RIVERBEND CROSSING FILING NO. 1

STREET IMPROVEMENT, STORM SEWER, AND SIGNAGE & STRIPING CONSTRUCTION DRAWINGS

EPC STORMWATER REVIEW COMMENTS ARE SHOWN IN ORANGE BOXES WITH BLACK TEXT

RIVERBEND CROSSING
FILING NO. 1
STREET, STORM, & STRIPING
CONSTRUCTION DRAWINGS

SOUTHMOOR DRIVE W/O CURB & GUTTER-WIDENING DETAIL URBAN RESIDENTIAL COLLECTOR
STA: 10+72.2 TO STA: 11+82.2
SCALE: N.T.S.

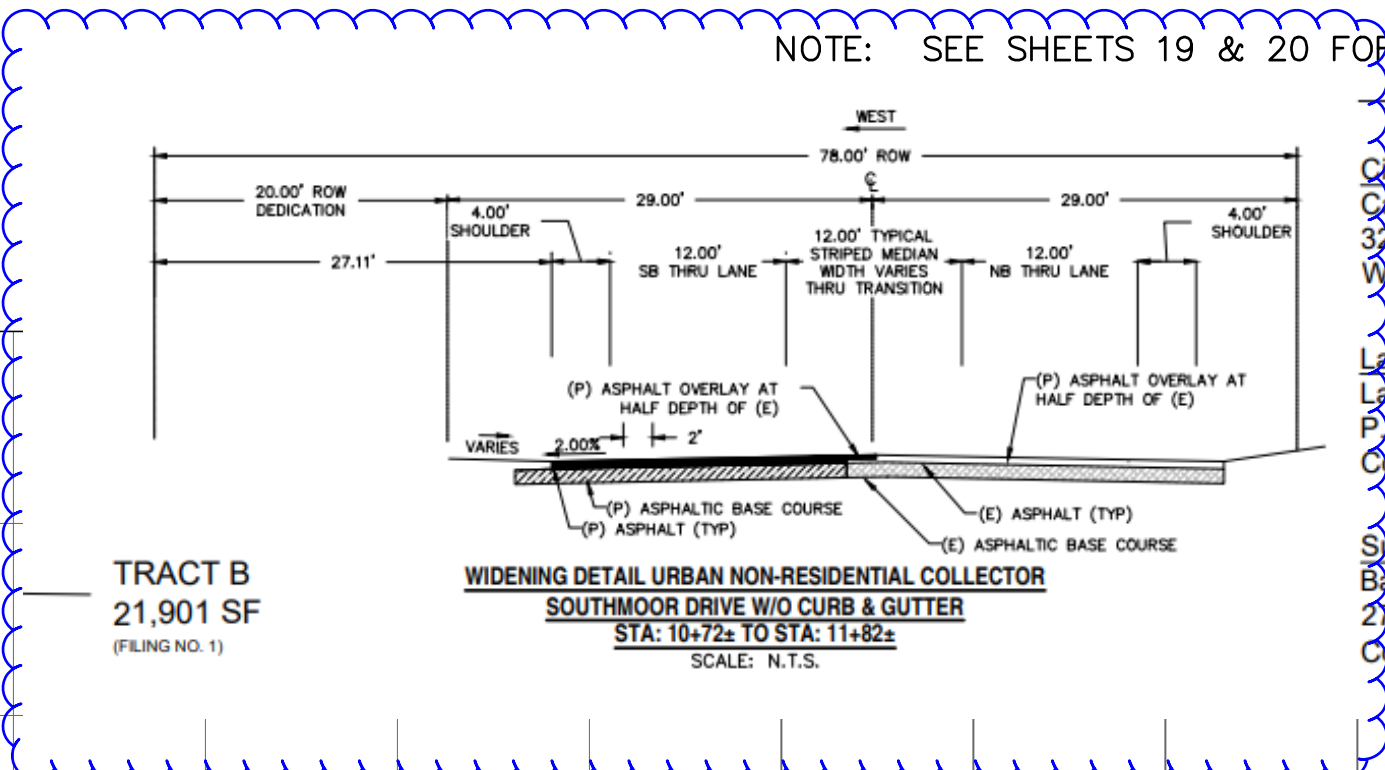
Update Southmoor Drive per the preliminary plan. Snippet below

Update Southmoor Drive per the preliminary plan. Snippet below

WIDENING DETAIL URBAN NON-RESIDENTIAL COLLECTOR
SOUTHMOOR DRIVE W/O CURB & GUTTER
STA: 10+72.2 TO STA: 11+82.2
SCALE: N.T.S.

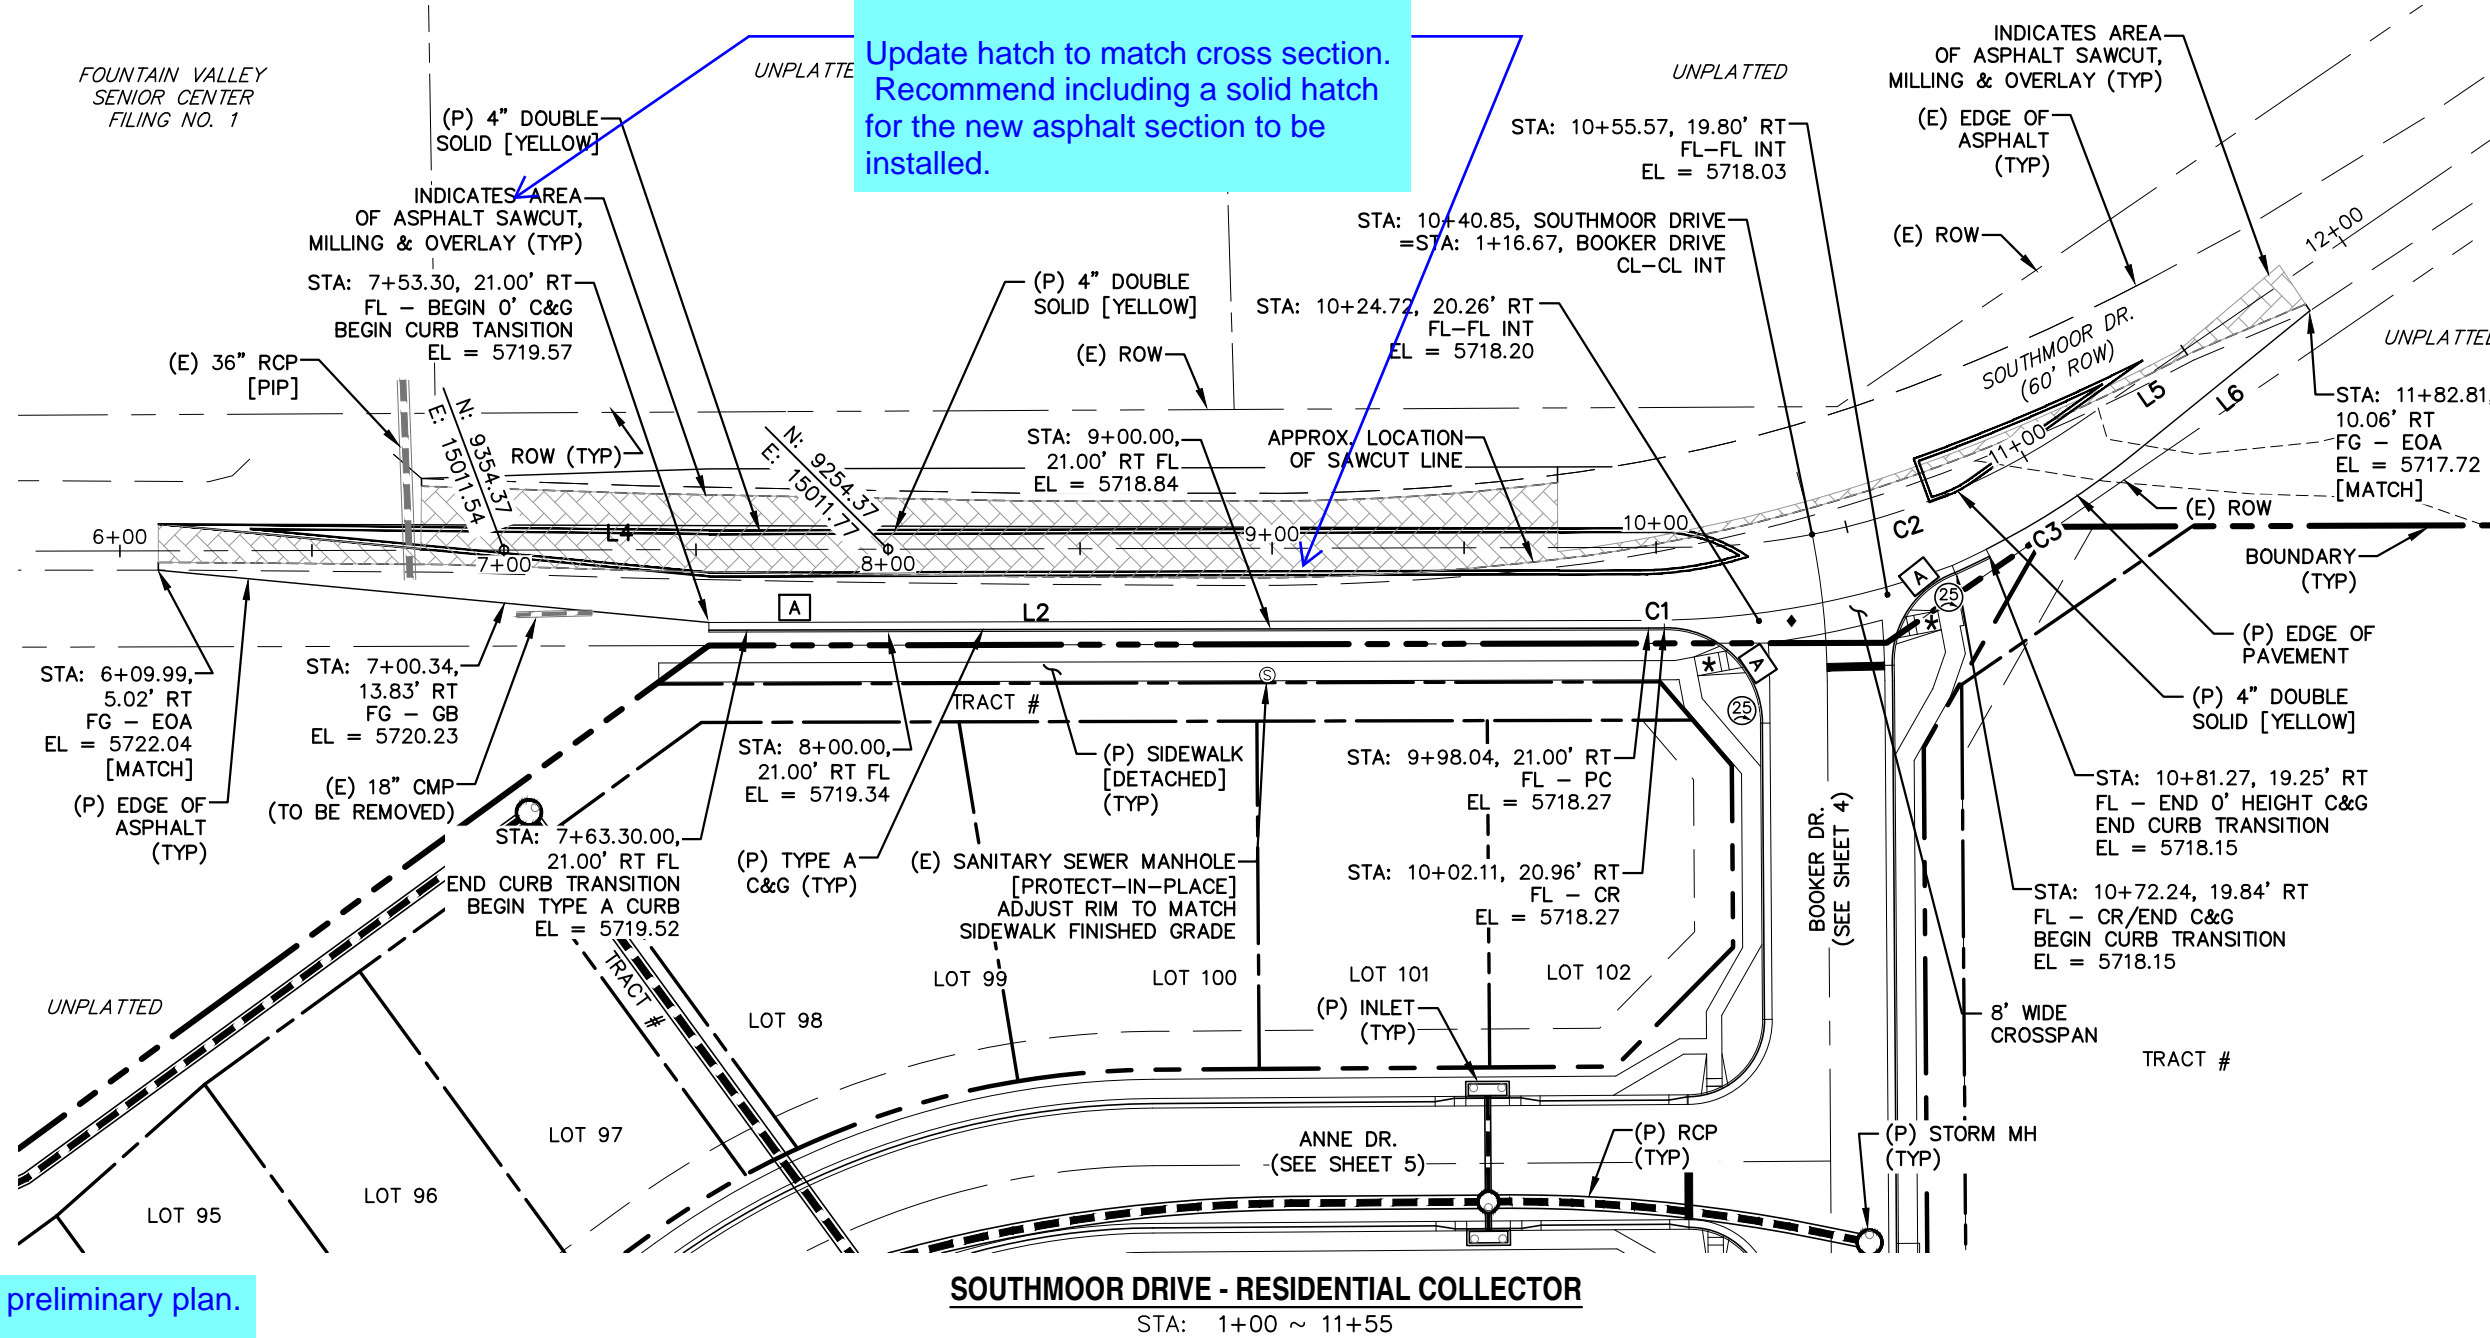
What's shown is confusing for mill/overlay and does not seem to match the typical cross section.
Update hatch to match cross section. Recommend including a solid hatch for the new asphalt section to be installed.

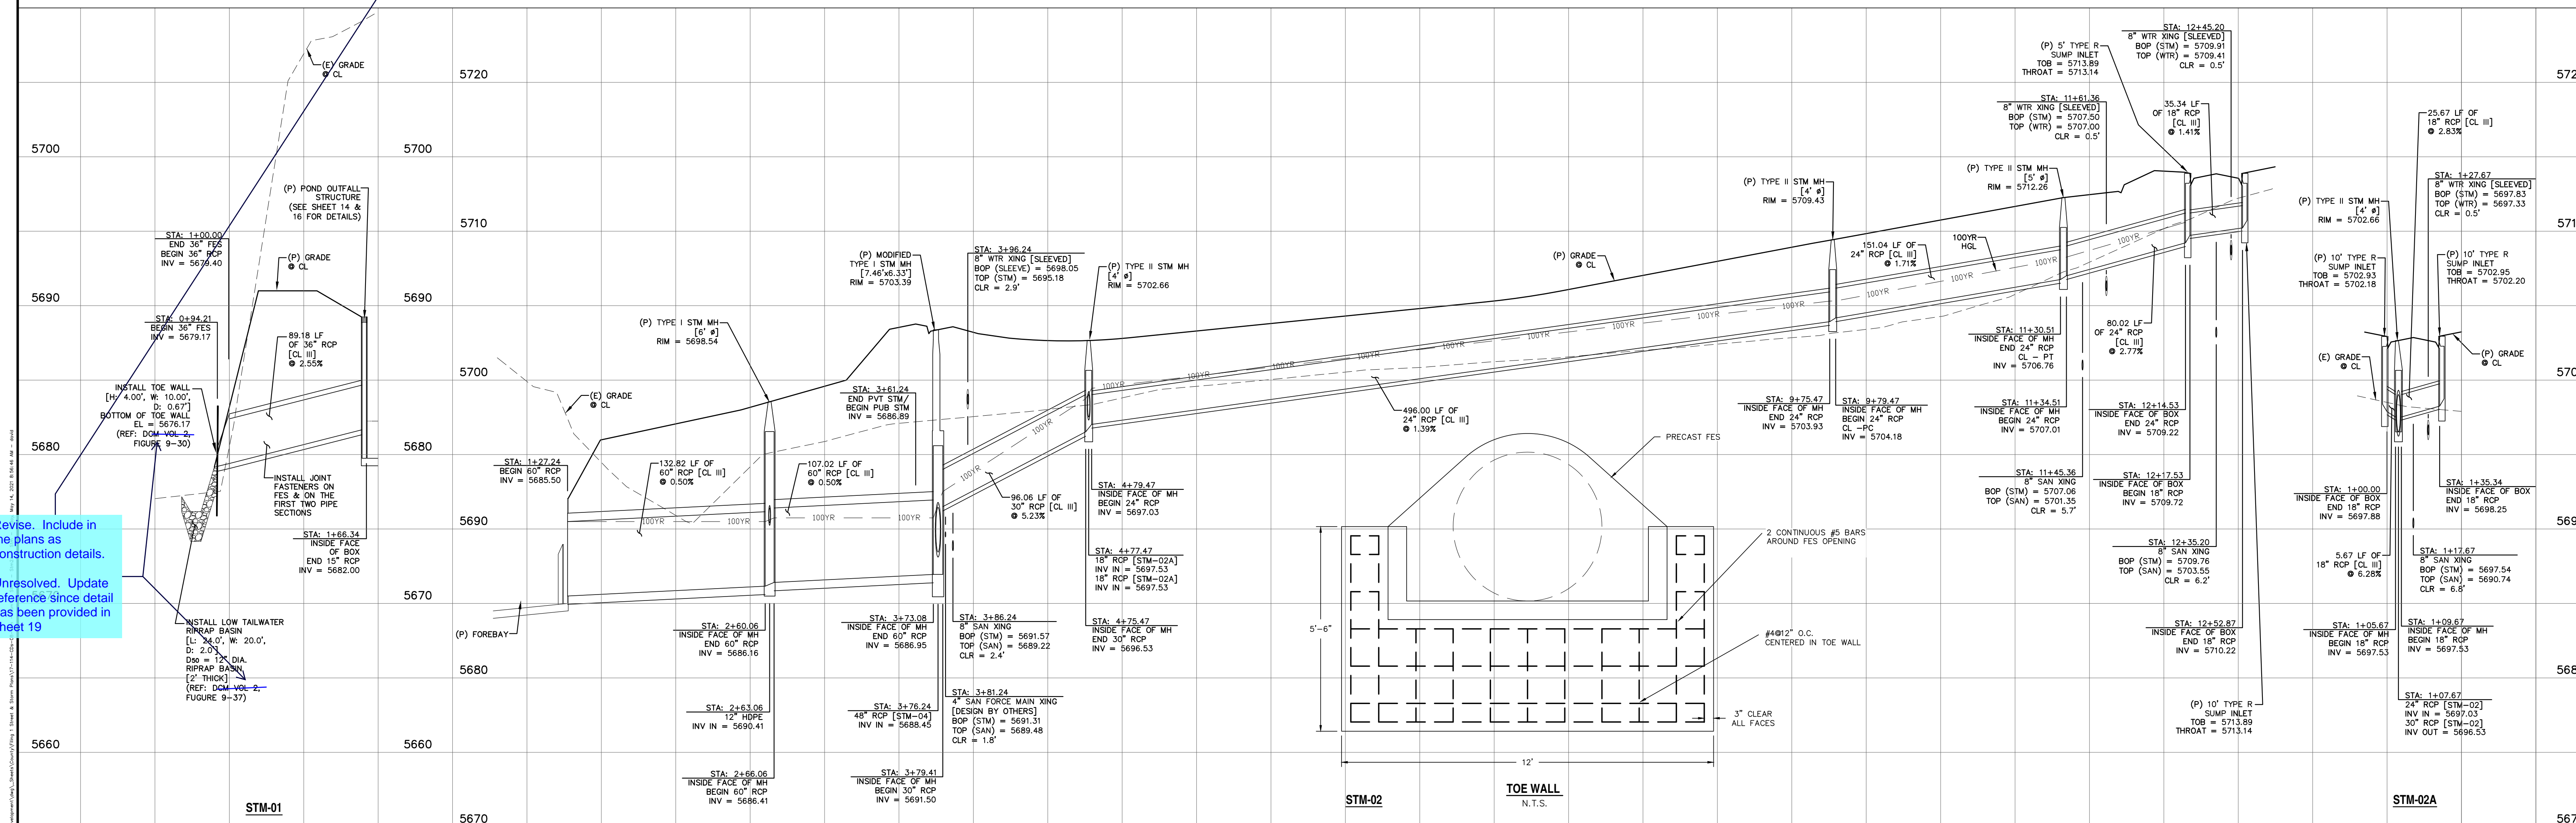
Revise. Include in the plans as construction details.
Unresolved. Update reference since detail has been provided in sheet 19

DESIGNED BY:	DLM	DRAWN BY:	MGP
SCALE:	1" = 30'	DATE:	03/30/21
JOB NUMBER	17-114	SHEET	14 OF 27

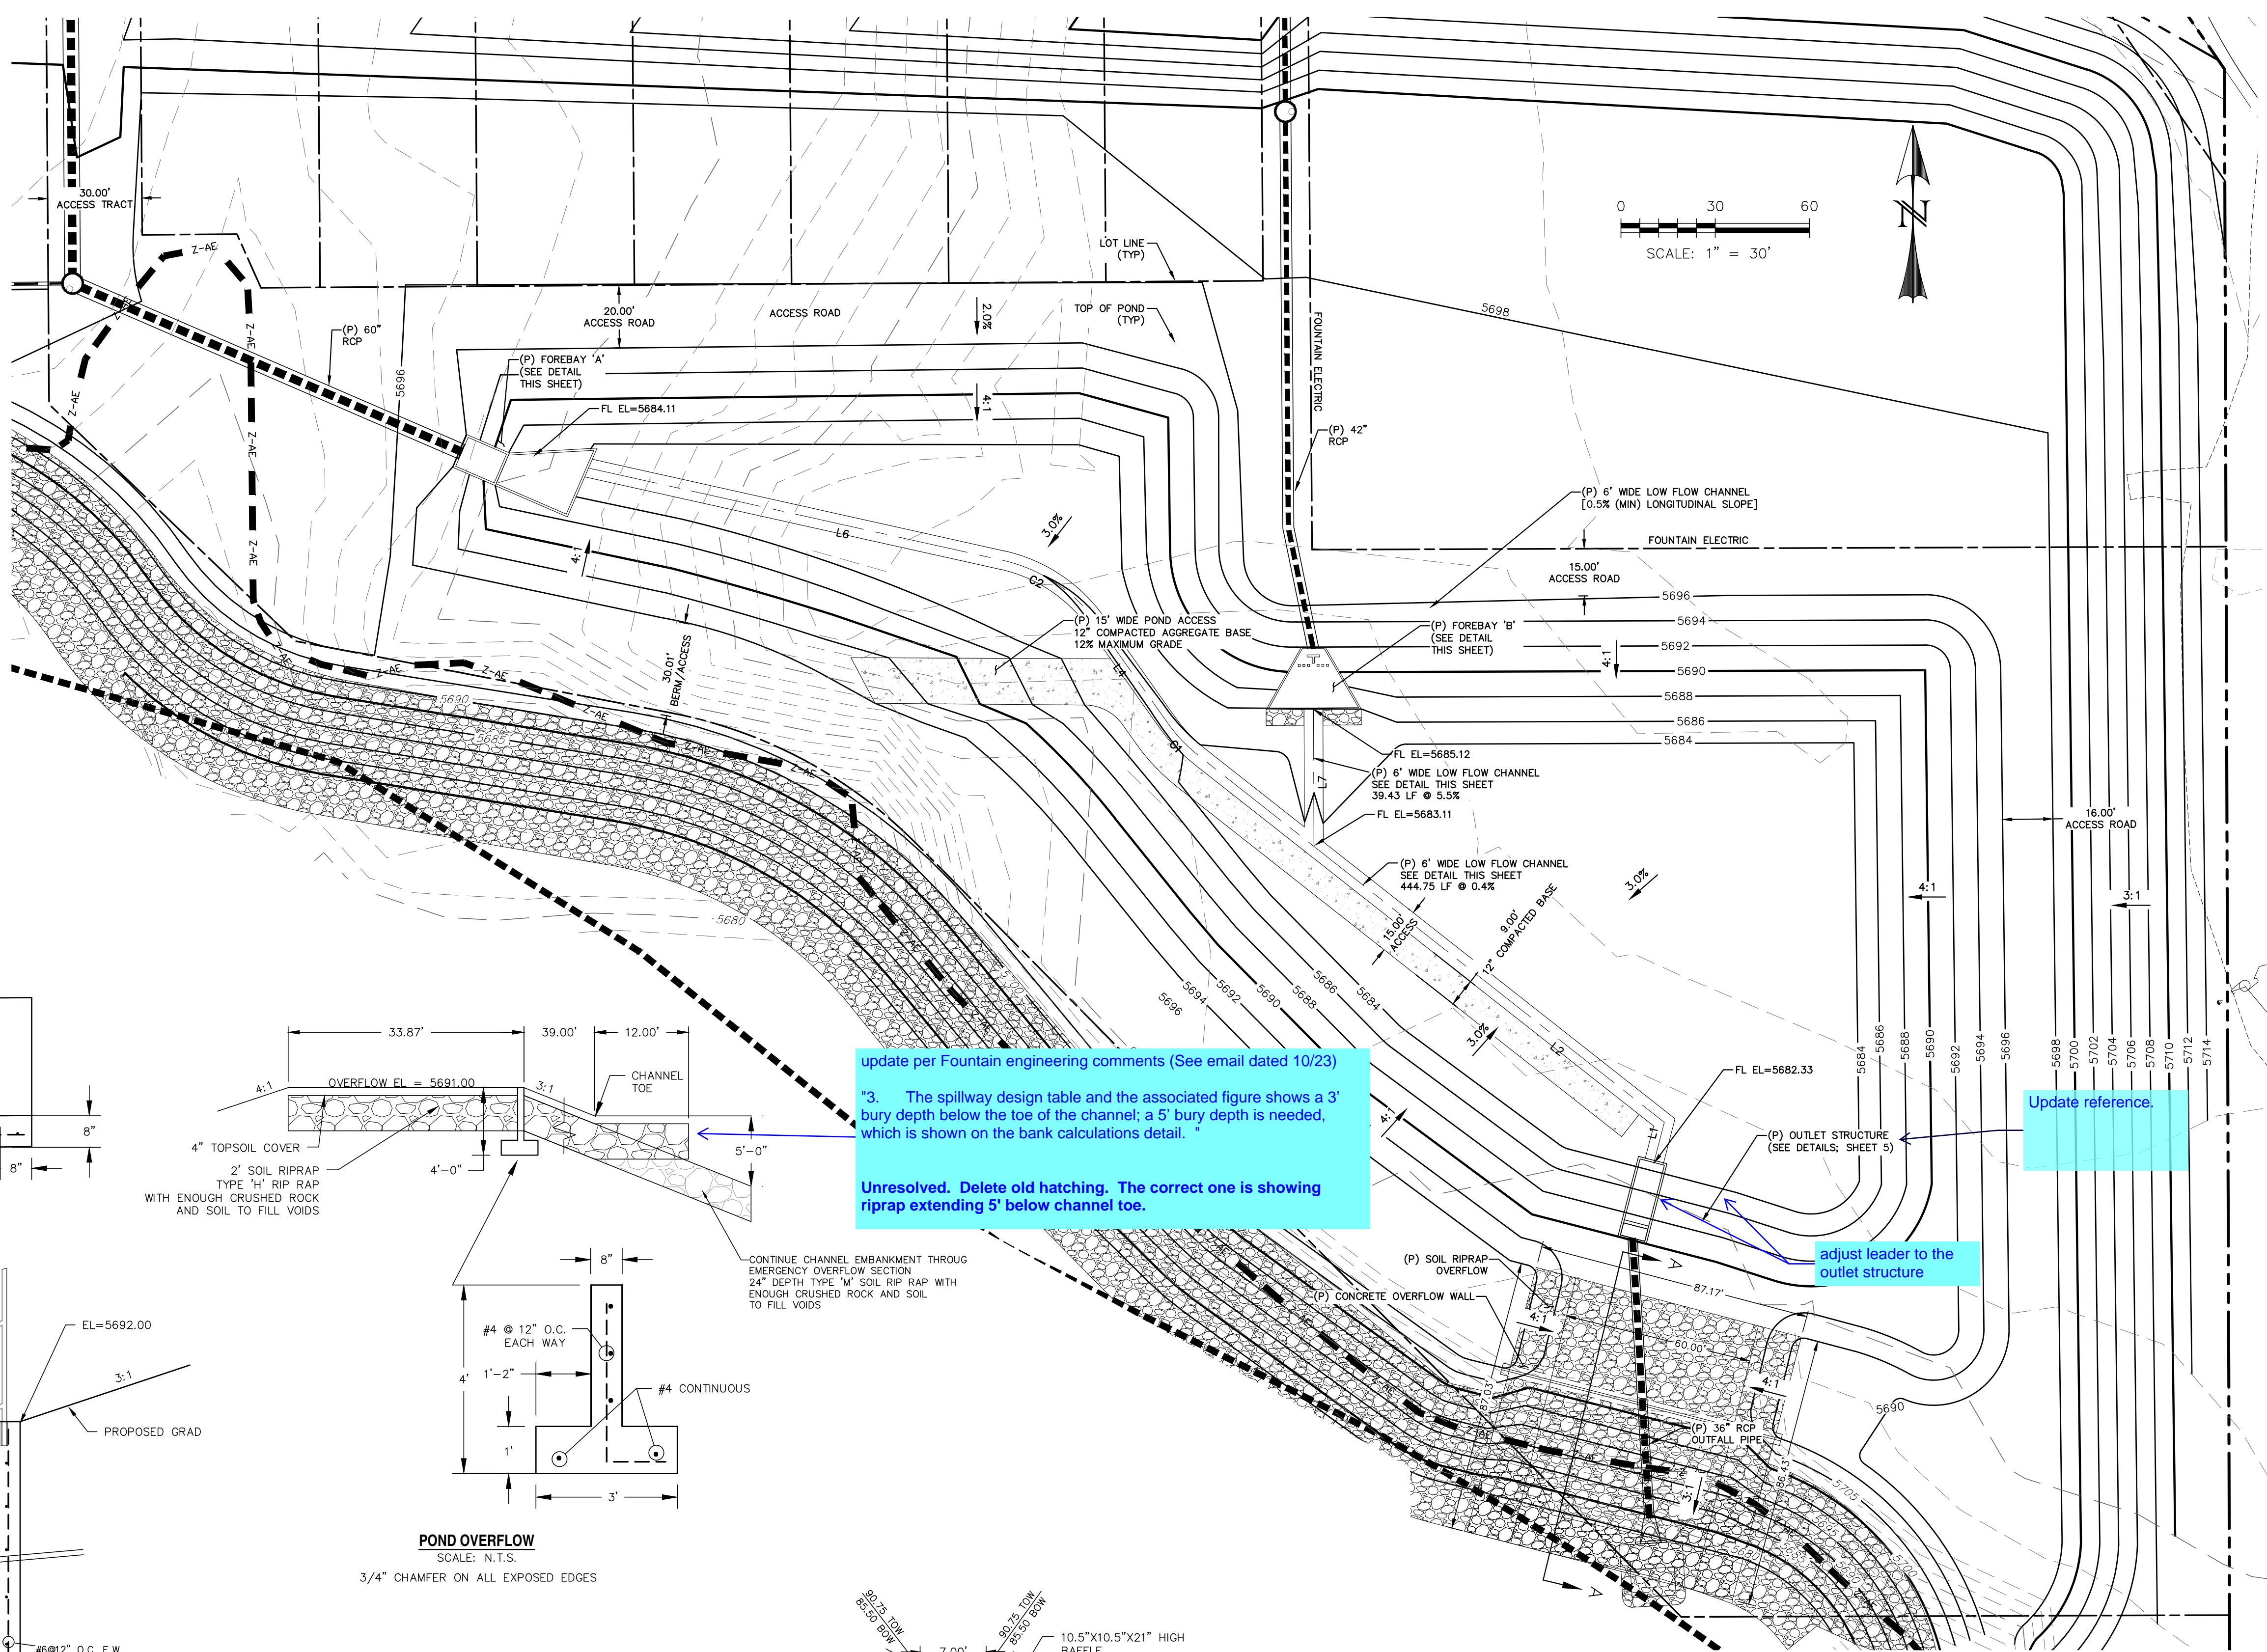
update per Fountain engineering comments (See email dated 10/23)

"3. The spillway design table and the associated figure shows a 3' bury depth below the toe of the channel; a 5' bury depth is needed, which is shown on the bank calculations detail. "

Unresolved. Delete old hatching. The correct one is showing riprap extending 5' below channel toe.

adjust leader to the outlet structure

Update reference.
